<h1 style="text-align: center;">TSB-Local</h1>	<b>Model</b>	Carnival/Sedona [VQ](), ( )
	<b>Group</b>	Automatic Transaxle System(52)
	<b>TSB No.</b>	KCE12-52-P170-VQ;C21VA
<b>Subject</b> <h2 style="text-align: center;">Sedona (VQ) 6 speed automatic transaxle inhibitor switch bracket installation</h2>	<b>Published</b>	10/23/2012
	<b>TSB Type</b>	Customer Satisfaction(Complaint Base)
	<b>Area &amp; Distributor</b>	U.K (C21VA)

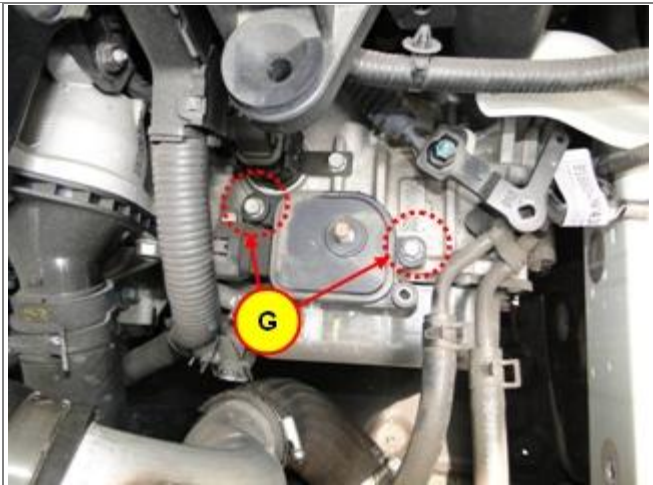
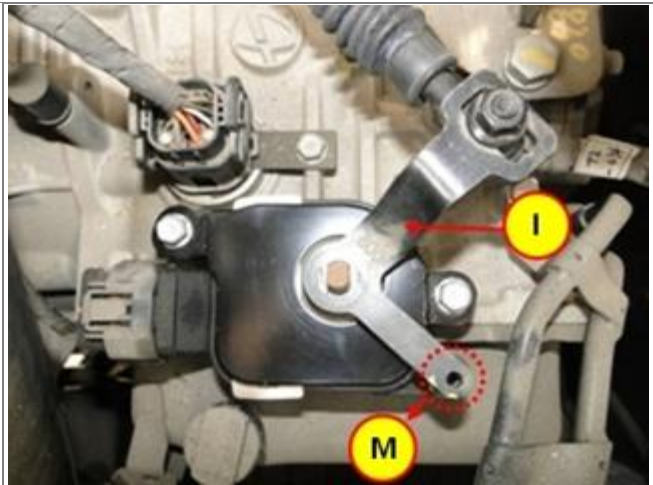
Some Sedona (VQ) vehicles might experience shock when shifting gear.

This symptom may be accompanied by DTC P0705.

Install the inhibitor switch bracket to the inhibitor switch following the Service Procedure below.

7. Remove 2 inhibitor switch mounting bolts (G).

8. Install the new inhibitor switch bracket (H) to the inhibitor switch.

9. Install the new 2 inhibitor switch bracket bolts (G).

**9.8~11.8Nm (1.0~1.2kgf.m, 7.2~8.7lb-ft)**
